EAGLE MOUNTAIN PLANNING COMMISSION MEETING

October 12, 2021, 5:30 PM

6.A [Action Item - Eagle Mountain Medical Office Building](#)

TITLE:	Action Item - Eagle Mountain Medical Office Building		
ITEM TYPE:	Site Plan		
FISCAL IMPACT:			
APPLICANT:	Jared Pinegar / Bruce Fallon		
GENERAL PLAN DESIGNATION	CURRENT ZONE	ACREAGE	COMMUNITY
		.95	Ranches Gateway

2A NORTH ELEVATION
1/8" = 1'-0"

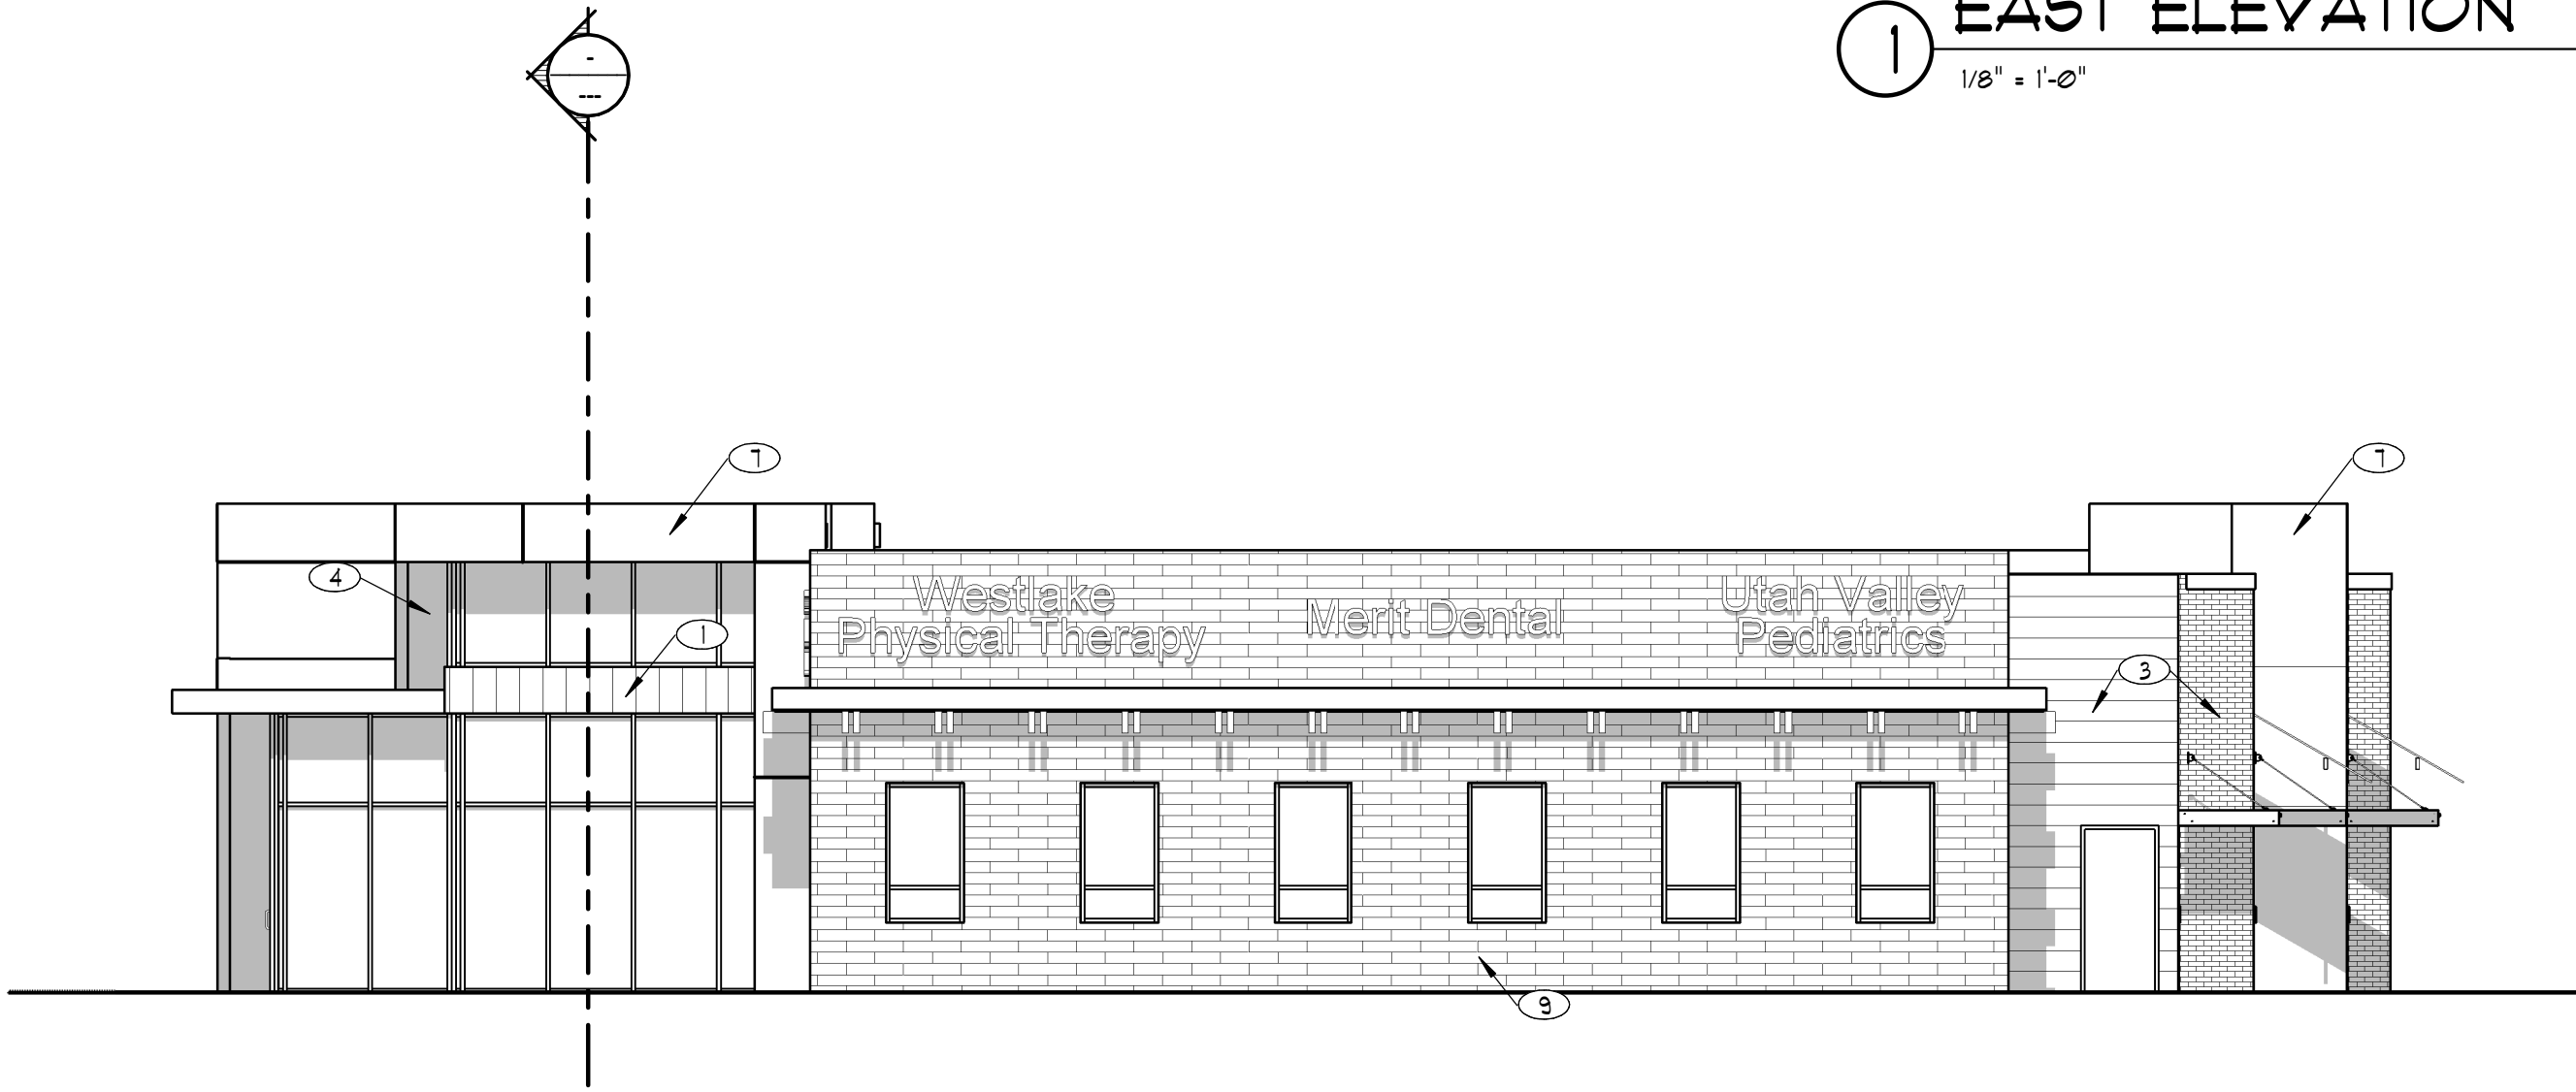
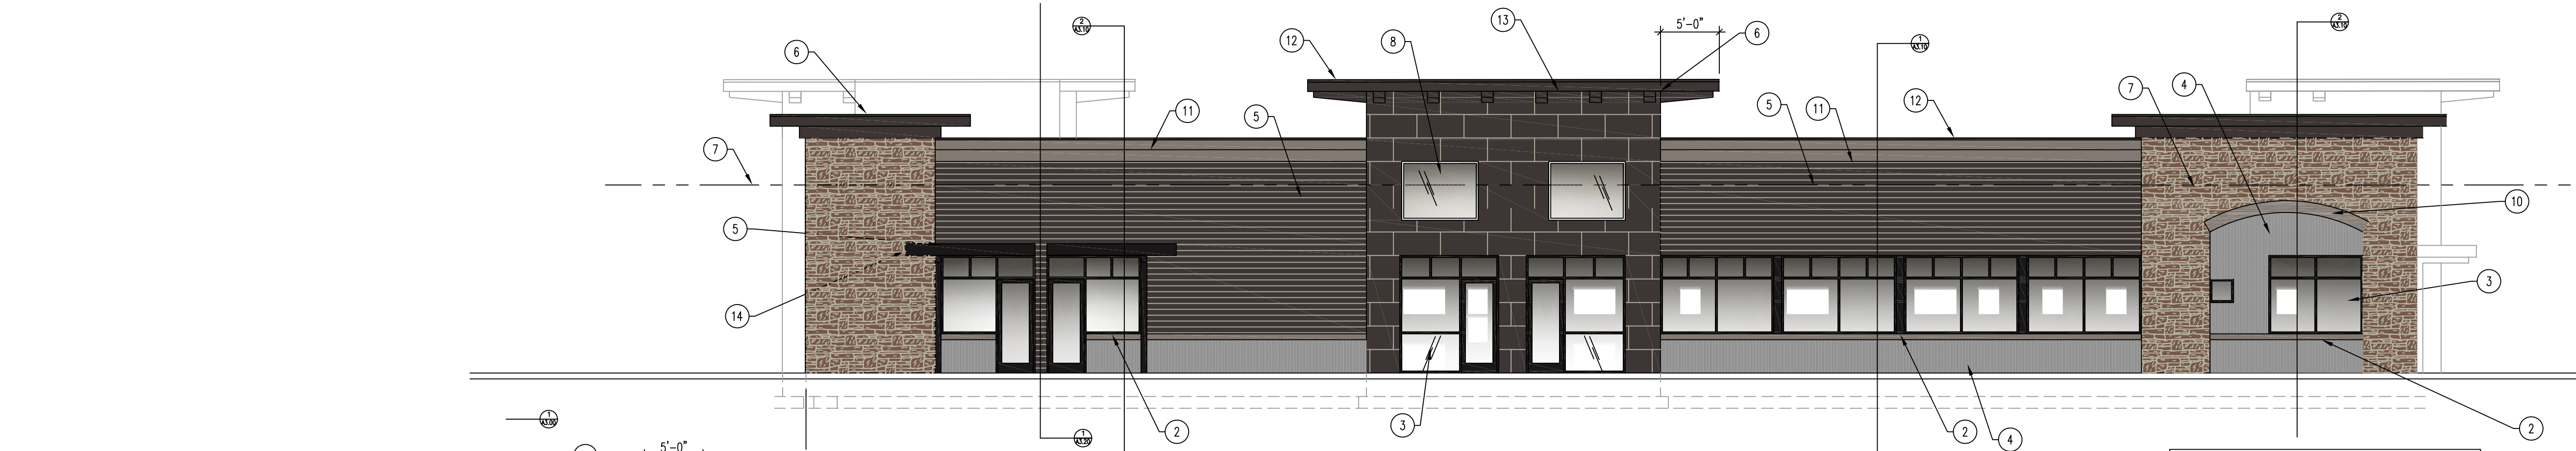
1. Drive aisle at rear of lot be continued to East property line.
2. Additional design elements are added to the North Elevation as required by 17.72.030 A1
3. Additional vertical and horizontal articulation and features on north and west elevations as required by 17.72.040 D
4. Chosen architectural features shall be used on all 4 sides of the building in accordance with 17.72.040 E1
5. Additional materials added to West and North elevations to eliminate featureless surfaces in accordance with 17.72.040 F2
6. LocalScape or other waterwise landscaping is required.
7. Monument Sign shall be located on applicants property.

Per 17.72.030 A 1 "The primary entrance to a commercial building should be oriented toward the street and the sidewalk. Orienting the primary entrance to a parking area without addressing the street-facing façade with entrances, display windows, awnings, increased architectural elements, increased landscaping, and/or other pedestrian-oriented features is prohibited" The North elevation which is facing Pony Express Parkway is largely flat, with fewer architectural details than the rest of the building. It is the opinion of staff that additional design elements need to be added to the north elevation.

17.72.040 D Requires vertical and horizontal articulation on all four sides of the development. the East and South elevations provide good articulation, the west elevation provides some articulation, but in the opinion of staff additional articulation is needed. The North Elevation is largely flat with a single flat plane of color dominating the visual. Staff recommends additional design elements be added to the North and West elevations.
